From: Matt Dumont
To: Cheryl Low
CC:
Date: 14/09/2026
Subject: RFI responses for groundwater modelling

This response memo has been prepared to address the concerns raised in the submissions received on the modelling work undertaken for the Bendigo Ophir Gold Project. Documents considered in this response memo are:

Figure 12.1: Total lost seepage percentage

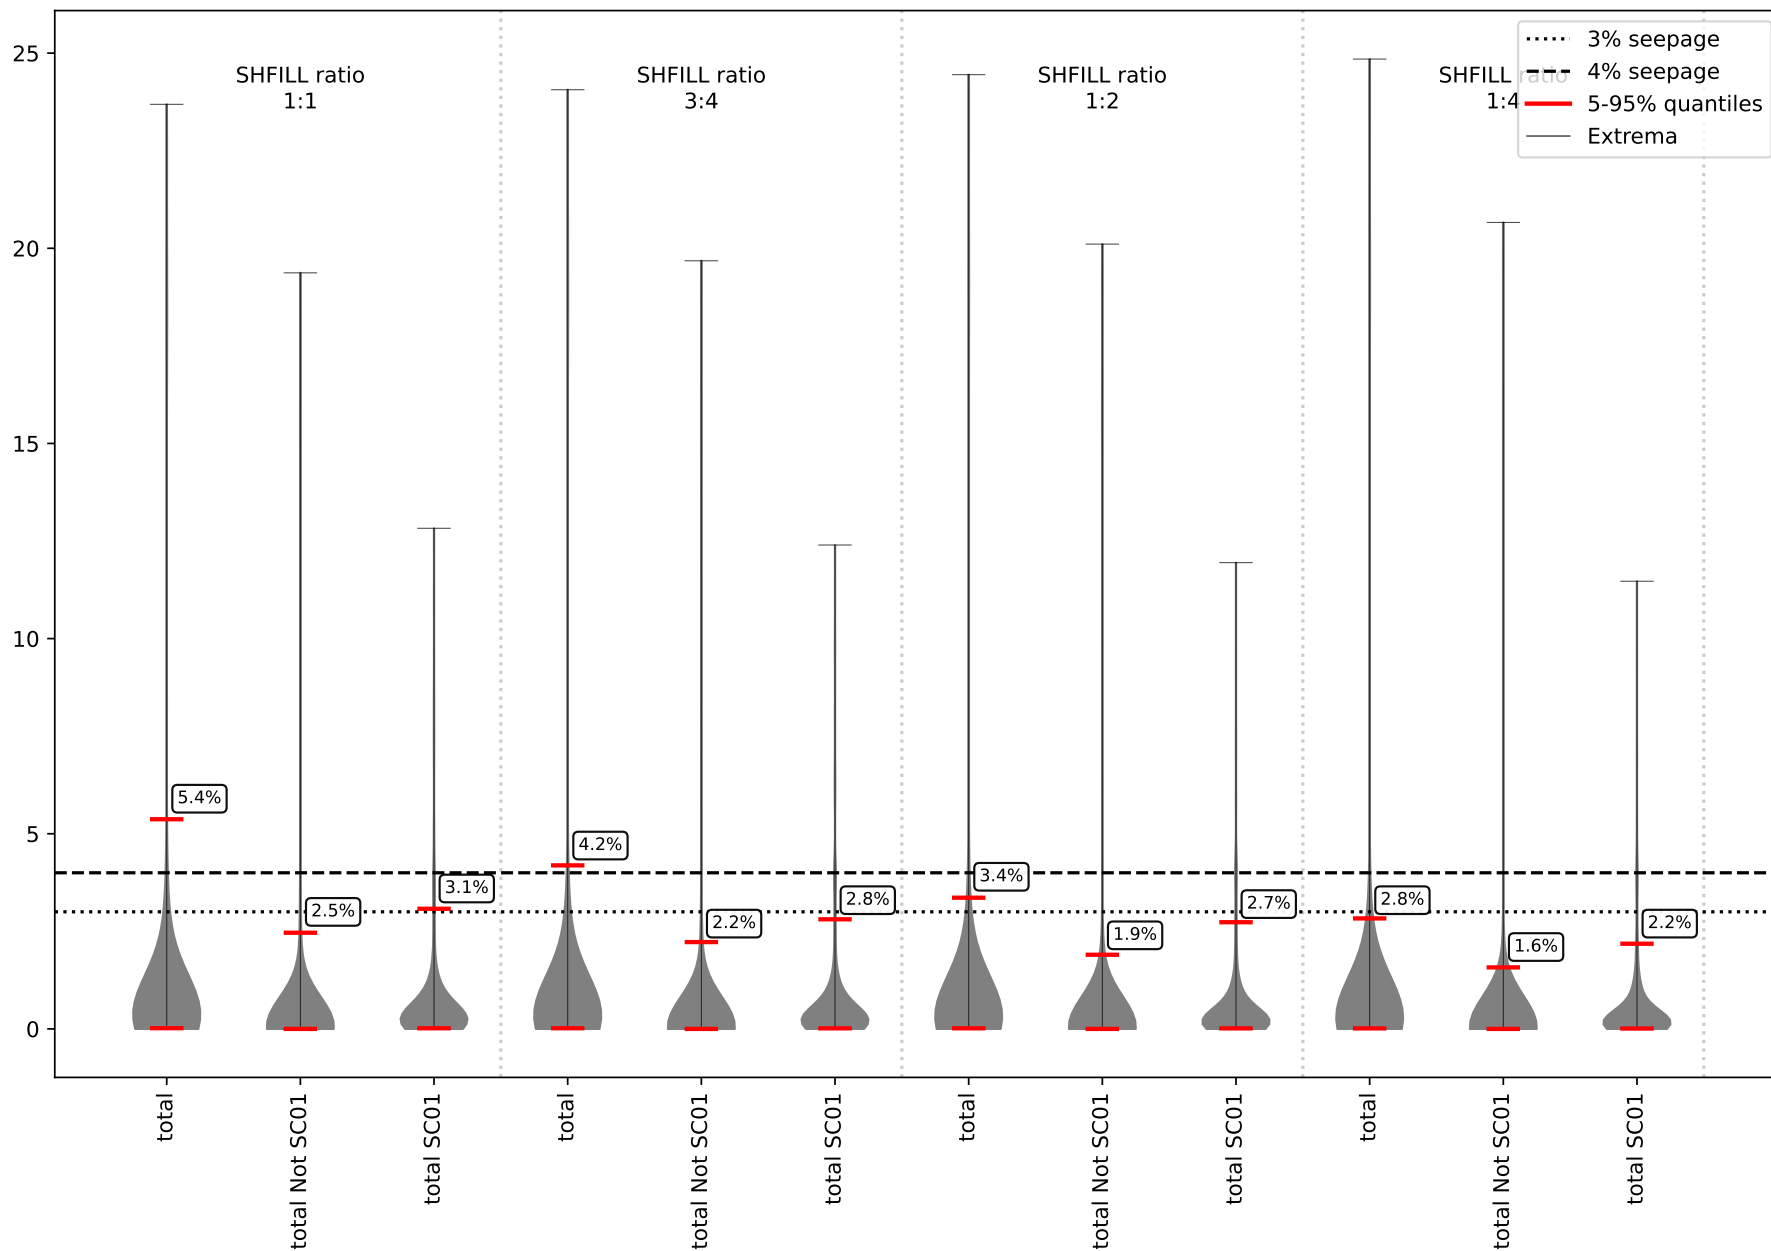
Greer (2026) raised concerns regarding the potential impacts of lost seepage on the Lindis River. Contaminant loading to the Lindis River was beyond the scope of our modelling work, which was focused on a relative assessment of the potential for seepage, not the total mass flux. We are not in a position to comment on the mass balance component of Greer (2026), but we do note a potential overestimate of the percentage of lost seepage in the assessment. Our analysis predicted the fractional lost seepage for each of the components of the mine site. It appears that Greer (2026) has summed the lost seepage at the 95th percentile for each component. This is not a valid approach as it assumes that the model parameters that yield very high seepage for one component (e.g., the TSF) are the same model parameters that yield very high seepage for another component (e.g., the SHFILL). Additionally, the source concentration of the different components are likely to vary. In particular, the SHFILL is made of much lower sulphur content material than the TSF and SHELF (Weber, 2025). It is beyond our scope to determine the relative source concentrations of the different components. However, to better support a discussion of the total lost seepage, we have compiled a total lost seepage assuming that the SHFILL has a source concentration ratio relative to the TSF and SHELF of 1:1, 3:4, 1:2, and 1:4. Here the percentage mass flux for each component is defined by:

Where sr is the lost seepage to the receptor (e.g., to the OFFSHORE zone), st is the total seepage mass from the component, and r is the source concentration ratio of the SHFILL relative to the TSF and SHELF. These results are presented in Figure 12.1. Further details on the apportionment between “total SCO1” and “total not SCO1” are presented in Section 11. Greer (2026) raises concerns that “A bypass rate of less than 4% would ensure that dissolved arsenic, zinc and antimony concentrations in the Lindis River do not increase above the ANZG 95% species protection threshold at MALF” and “A 3% seepage bypass rate at MALF is predicted to result in the ANZG (2018) 99% species protection threshold for dissolved zinc being exceeded” Greer (2026) considers the impacts of higher percentages of lost seepage (8% and 10%), which our model does not predict. Our results suggest that depending on the relative contribution of the SHFILL relative to the TSF and SHELF, the 95th percentile of the total lost seepage is very unlikely to be in excess of 5.4% with a large portion of this being discoverable by the monitoring network (e.g., SCO1 and adjacent groundwater). Note that most model realisations suggest that lost seepage will be far less than 3%. As shown in Section 9, the stochastic suite is biased towards higher rates of lost seepage, so the 95th percentile is likely to be a very conservative estimate of the potential for lost seepage. Further investigation of the model suite could refine the potential for lost seepage, but this was not possible within the time constraints of the modelling work and this response. Based on the results of our modelling, our experience with this model and the simplifying assumptions therein, and the conservative nature of the stochastic suite, we suggest that reaching the 95th percentile of lost seepage is very unlikely to occur. Table 12.1 presents the 5th, 10th, 25th, 50th, 75th, 90th, and 95th percentiles of the total lost seepage for the different source concentration ratios. Even at the 90th percentile and an assumed SHFILL source concentration ratio of 1:1, the total lost seepage is unlikely to exceed 2% which is lower than species protection thresholds raised in Greer (2026). The significant difference between the 90th and 95th percentiles is indicative of the impact of extreme outliers in the posterior distribution. Further investigation of these outliers could provide insight into the very unlikely and possibly implausible conditions that yield these extreme values in the model, but this was not possible within the time constraints of the modelling work and this response.

Total is all seepage lost to the surface drains, OFFSHORE zone, and SiltPond. Not SC01 refers to the lost seepage to the OFFSHORE, and drainage systems that may not be captured by SC01 or nearby groundwater (e.g., d-catchment-sc-1). SC01 refers to the other lost seepage, which will likely be captured by SC01 or adjacent groundwater. See [Section 11](#) for further details.
